MISSISSIPPI POWER & LIGHT COMPANY

July 26, 1984

SUBJECT: Grand Gulf Nuclear Station  
Units 1 and 2  
Docket Nos. 50-416 and 50-417  
License No. NPF-13  
File: 0260/L-860.0  
Additional Information - TDI Engine  
Inspection  
AECM-84/0386

TABLE 1  
Cylinder Head Baseline  
Data for Flatness

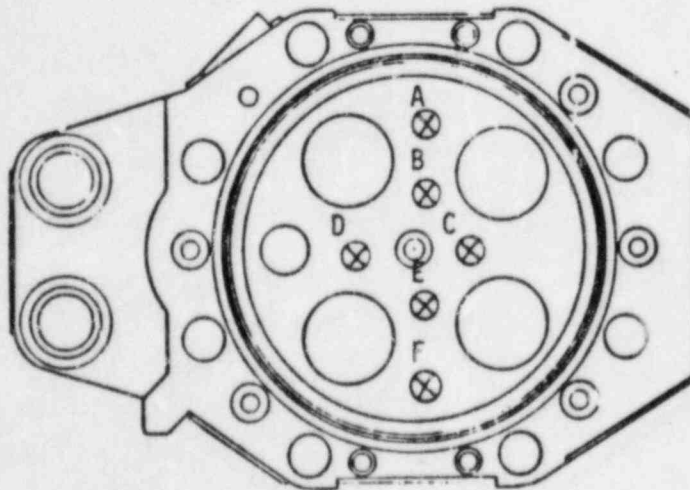
4. Documented results of measurements of the cylinder head fire deck surface flatness.

A straight edge and micrometer were utilized to obtain baseline information for the cylinder head fire deck profiles. Measurements were taken at six different locations on the fire deck. Readings varied from head to head as to the depth of the fire deck depression. Results of the measurements are shown in TABLE 1.

Changes in readings taken across the fire deck were due to the curvature of the fire deck and were consistent for all heads and did not indicate a problem with head warpage. These readings were taken for baseline data to be used in the future to determine if warpage of the heads may have occurred.
